Office of Licensing, Climate and Resource Use,  
Environmental Protection Agency,  
P.O. Box 3000,  
Johnstown Castle Estate,  
Co. Wexford

**Re: Doon Farm Enterprises Ltd. ~ Licence Application P1024-02**

I refer to previous Agency correspondence of 25<sup>th</sup> April 2023. Please find the response to the issues raised outlined below;

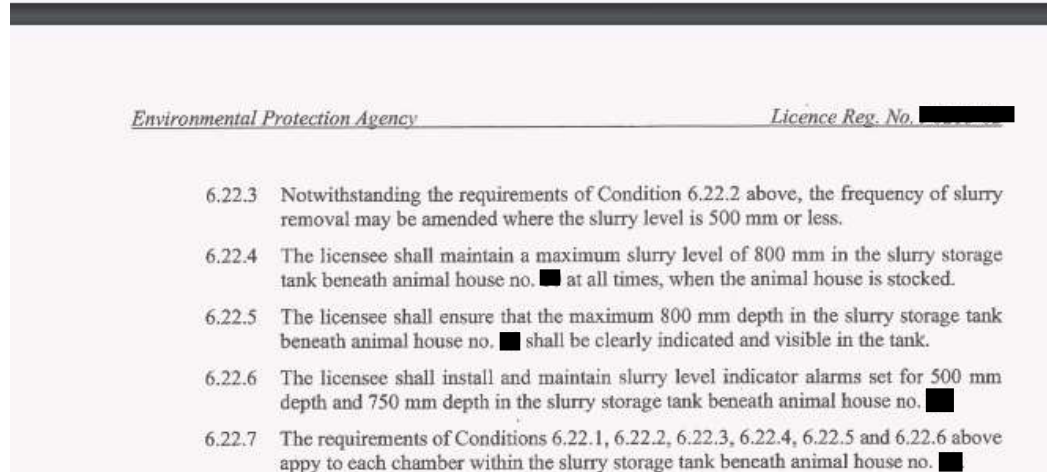
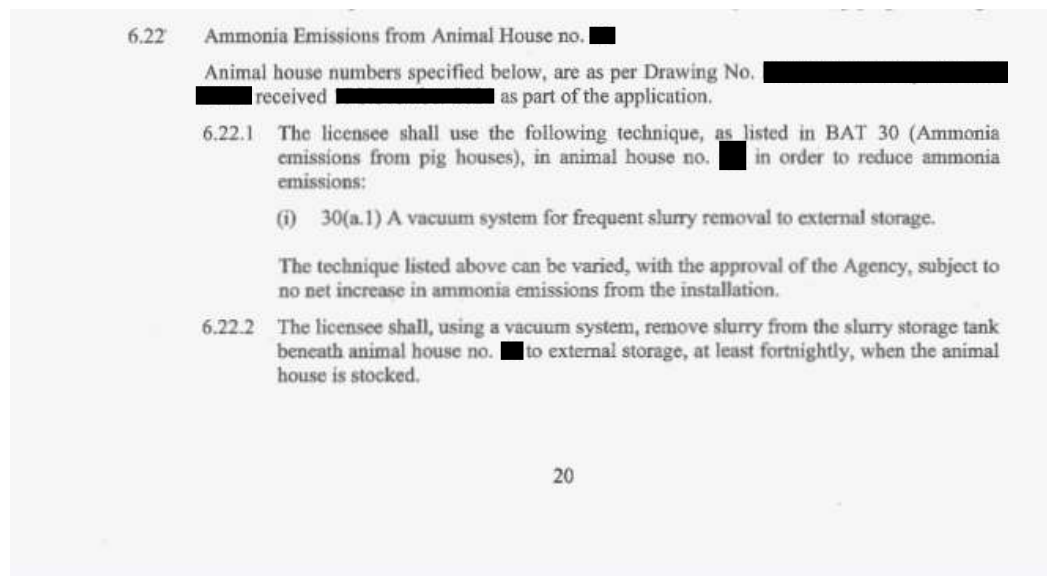
**The response provided regarding BAT 30 was not complete. You are required to submit the following outstanding information in relation to houses A, B, 2.1 and 10.1:**

- a) **Specifically reference the technique or combination of techniques that are proposed to be utilised. Your response of 21 March 2023 lists possible scenarios only. Confirm which of the two techniques referenced will be implemented.**
- b) **Provide sufficient detail to clarify how the measures proposed will comply with the specific BAT technique referenced. Your response of 21 March 2023 lists possible scenarios but did not provide any specific details of how the applicant proposes to comply with Commission Implementing Decision (CID) document for the Intensive Rearing of Poultry or Pigs (2010/75/EU, Feb 2017). The application cannot progress without sufficient detail to demonstrate compliance with BAT 30:**

**2.B.1) It is proposed to operate a frequent slurry removal system in Houses B, 2.1, 10.1 & 10.2).**

**If BAT 30(a.1), a vacuum system for frequent slurry removal (in case of a fully or partly slatted floor) is to be implemented, the following is required:**

- i. The method and frequency of slurry removal including details on the type of vacuum system proposed and how restrictions in the slurry depths in the tanks under houses A, B, 2.1 and 10.1 will be managed;

- ii. The type and capacity of external slurry storage proposed on-site to facilitate implementation of this BAT technique;

- iii. Revisions to the on-site slurry storage capacity taking account of the restrictions in depth that would be required in the tanks under Houses A, B, 2.1 and 10.1 and the external slurry storage tank(s) as per points i. and ii. above; and

**Slurry Management will be in line with other existing licenses as issued by the Agency As detailed below;**

**No additional on-site storage is proposed. Slurry is to be exported off-site to additional storage facilities to be provided by the applicant, who utilizes organic fertiliser from this farm in connection with his bovine farming enterprise. Said facilities have been approved by Tipperary Co. Co. under Planning Ref. 23/60788, and are to be completed forthwith.**

**Please refer to revised slurry storage capacity table attached.**
